DVOR Rationalisation  
Removal of Enroute Dependencies  
Trent (TNT) Deployment

## **DVOR TNT Holds and STARs**

Reference 5: Stakeholder Evidence for Stage 2  
As summarised in Annex H of Stage 2 Documentation

### 1. Email trail with East Midlands Airport to discuss RNAV 21/12/20

Existing

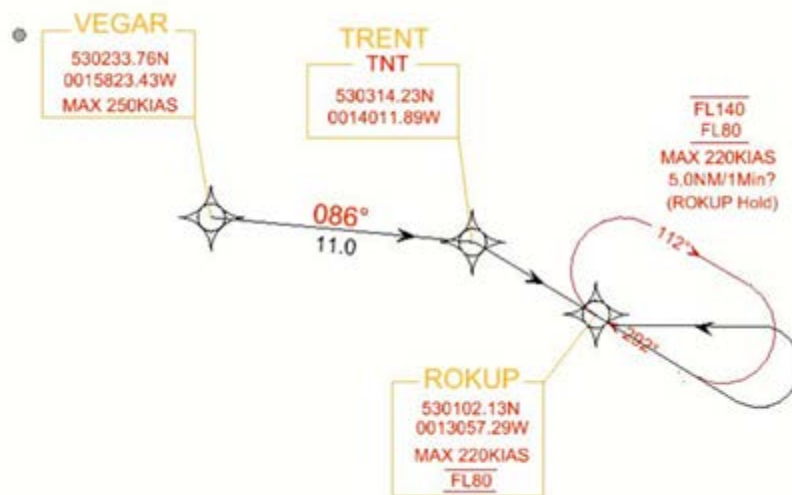
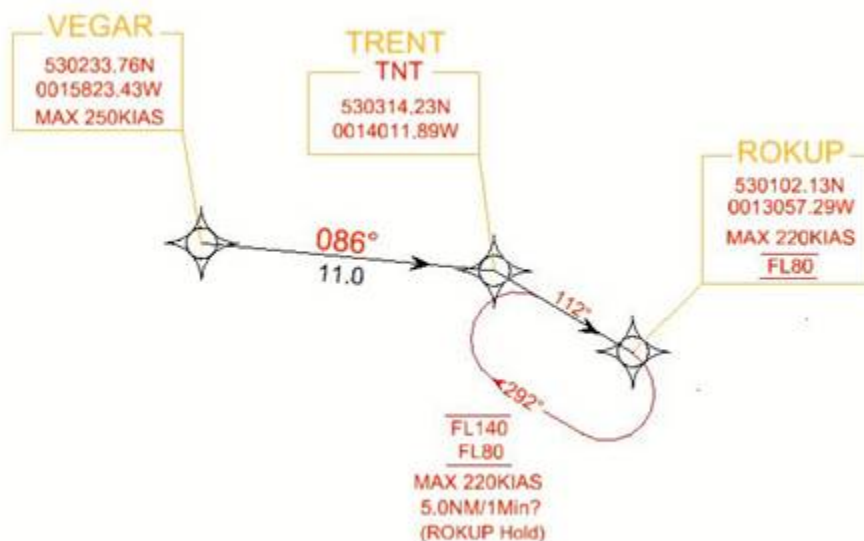
A couple of questions around the ROKUP hold.

The existing entry via DIPSO is quite convoluted and entry could be shortened (subject to CAA approval within the spirit of replication)

If the teardrop entry through ROKUP was utilised would this cause issues?

The other option not shown would be to use DIPSO as the hold with distance or time based as this will also generate enable fuel savings and remove reference to ROKUP . However, I'm aware that you have non radar procedures based on the current holds and but would need to be amended either in chart form and/or textual . In addition I presume an EFPS update may be required?

The other argument is holding is relatively rare at ROKUP and mainly confined to the evening arrivals on rare occasions ( You did hold recently when I was on an afternoon shift after my nice streaming but you did go into LVPs' at the wrong time!)

I'll start off by saying that the option for DIPSO is a non-starter as it will involve major work on our EFPS and this will be timely and costly and so there is no appetite for that at present. That will obviously change once we re-start our ACP at some point.

With regards to the other options, it would be good to see what quantifiable difference this would make to our operators. As you say, the holds are very rarely used and so I am of the opinion to leave them be at present and again see where we are with the ACP.
